STATE OF WASHINGTON
DEPARTMENT OF ECOLOGY

Re: Response to Comments for the Woodworth & Co. Lakeview Plant

Site Address: 2800 104th Street South, Tacoma, WA

VCP Project No. SW1012

Figure 1 – Water levels through time depicting well screen elevations for MW-11, MW-13, and MW-24.

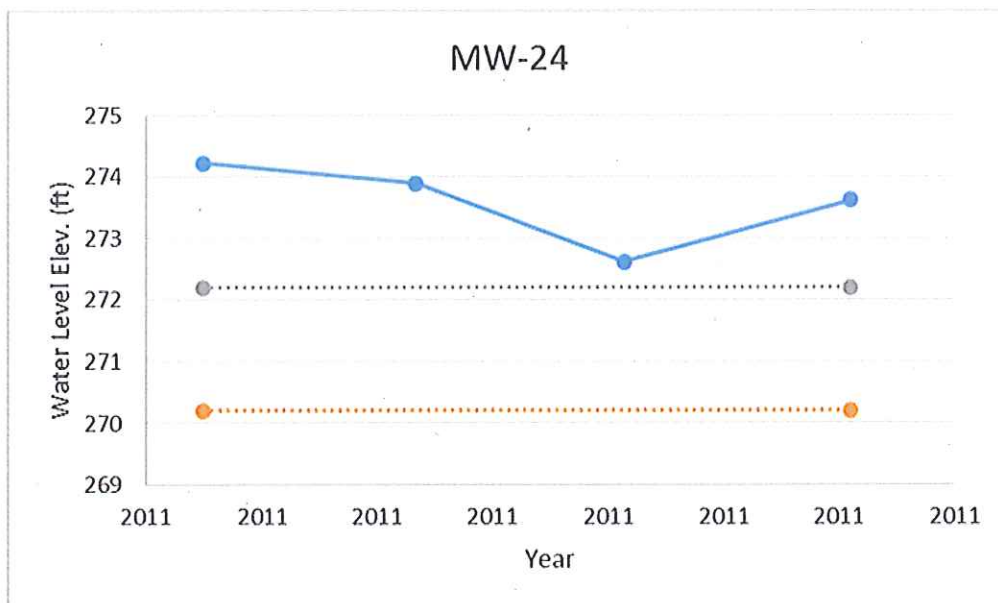
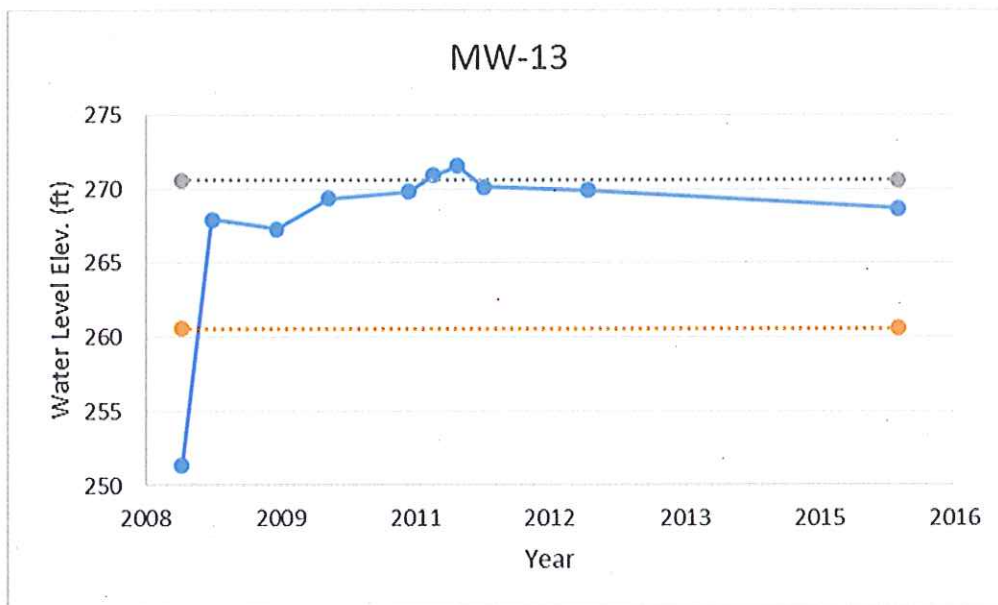
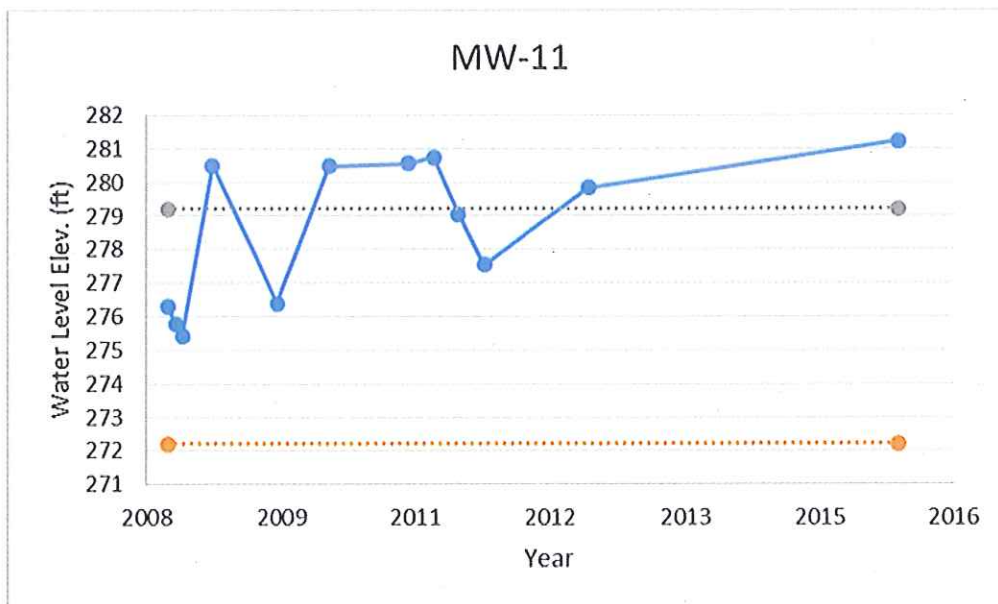
Item 1: Well Screens for Monitoring Locations MW-11, MW-13, and MW-24

In the 2016 Ecology Meeting Summary Email, Ecology expressed concerns over well construction, specifically screened intervals, for monitoring locations MW-11, MW-13, and MW-24. Although the aforementioned monitoring wells are periodically submerged (Figure 1), Total Petroleum Hydrocarbon (TPH) concentrations in groundwater at these locations are low (MW-11) to non-detect (MW-13 and MW-24), it is unlikely that such conditions will adversely affect groundwater monitoring results in a significant manner. Therefore, Ecology is not requesting further action regarding these locations at this time; however, additional, monitoring data is requested (Item 15, below) to establish current water levels at these monitoring locations.

Figure 2 – Map of the Chambers-Clover Creek watershed.

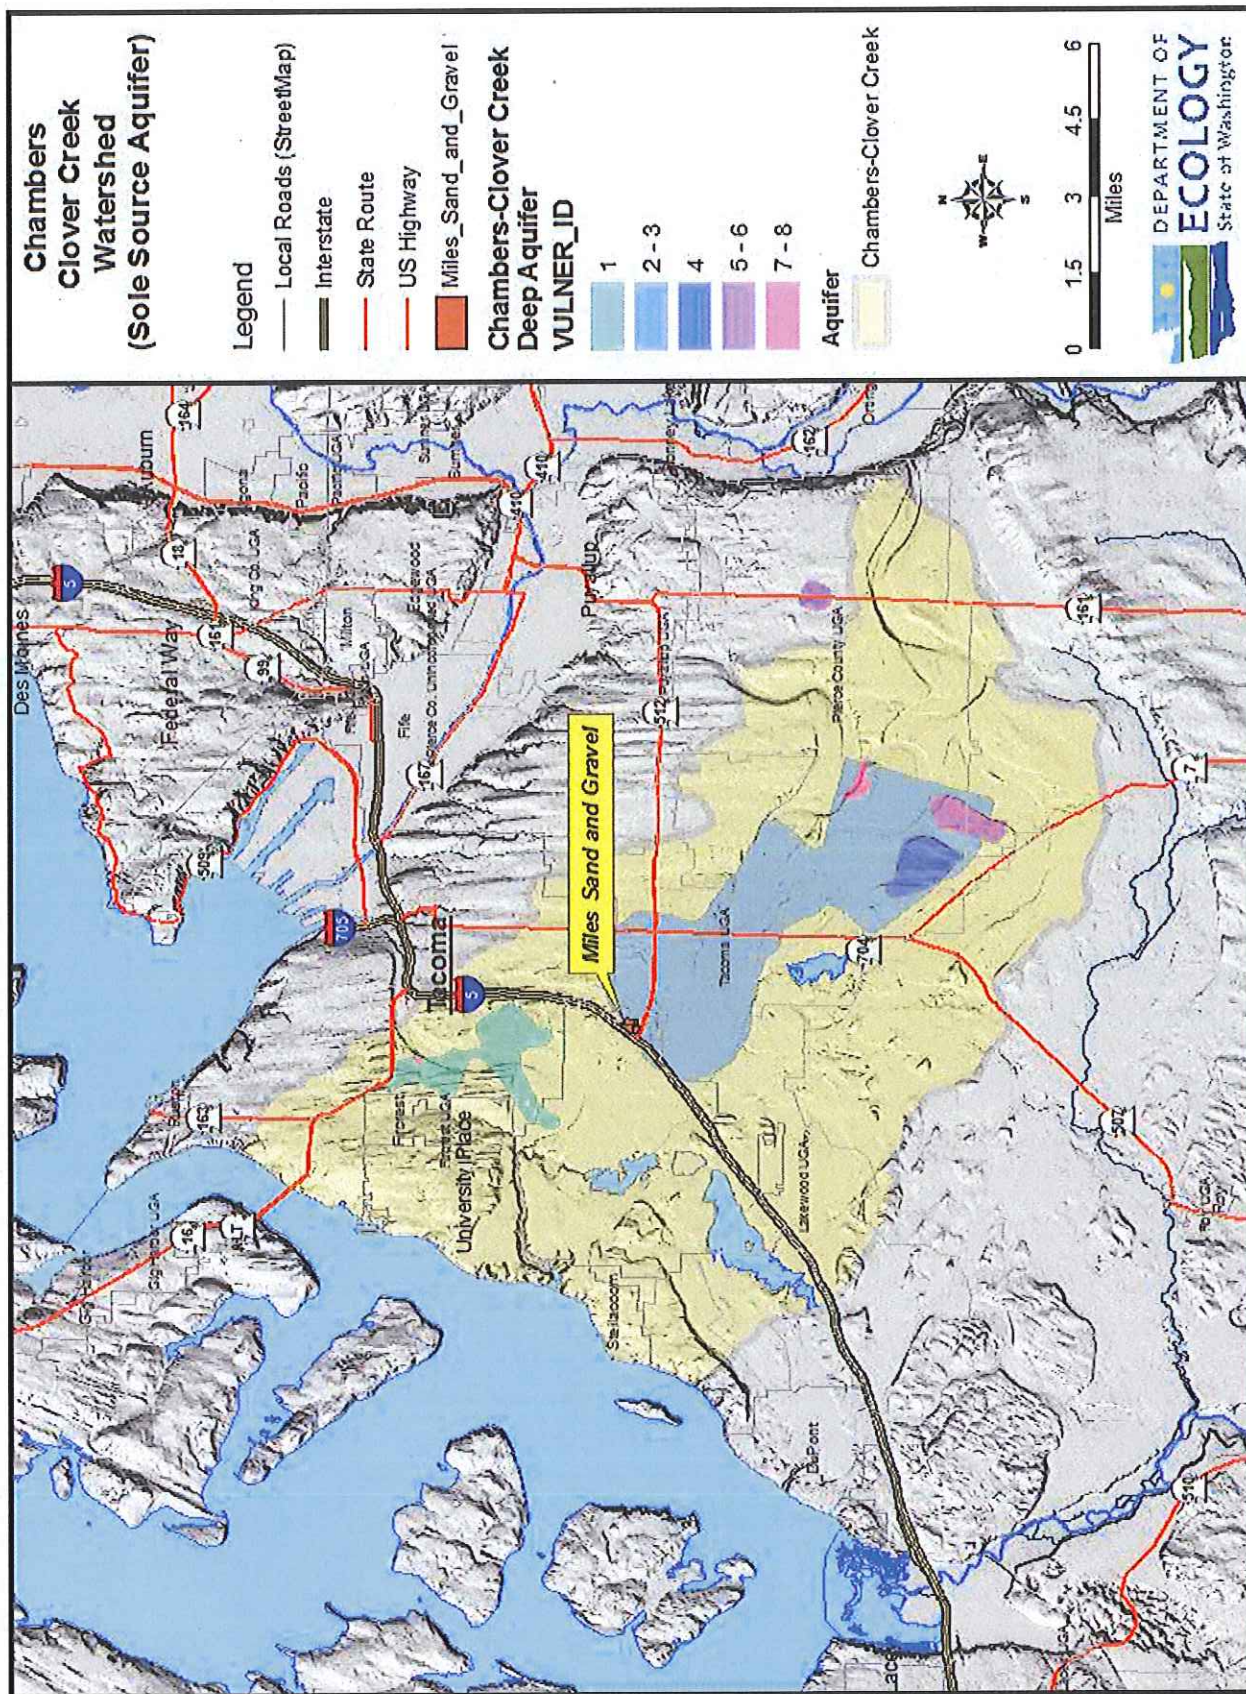
The Chambers-Clover Creek Watershed (Figure 2) has been designated as a Sole-Source Aquifer for approximately 400,000 residents in the DuPont, Fircrest, Lakewood, Steilacoom, Tacoma and University Place areas. Approximately 60 percent of the drinking water for these areas is derived from the Chambers-Clover Creek aquifer (EPA 2017). Seven municipal water-supply wells, designated as Group A / B wells, are located within 1-mile of the Site (Table 1, Figure 3) and draw from the Chambers-Clover Creek aquifers ranging in depths from 100- to 600-ft bgs. Two supply wells are located northwest of, and downgradient from, the dissolved-phase TCE impacts documented at the Site; the Laurel Lane Mobile Home Park (Well #1 ACV533) and Majestic Oaks Water System (Well #1; Table 1). The Laurel Lane trailer park well is approximately 108 feet in depth, and is located approximately 2,000 feet to the northeast of the Site. The Majestic Oaks Water System Well is approximately 150 feet in depth, and is located approximately 2,200 feet to the northwest of the Site. Because of their proximity to the Site and associated depths of these supply wells, Ecology requests that water samples be collected from both the Laurel Lane and Majestic Oaks supply wells for analysis of VOCs (EPA 8260).
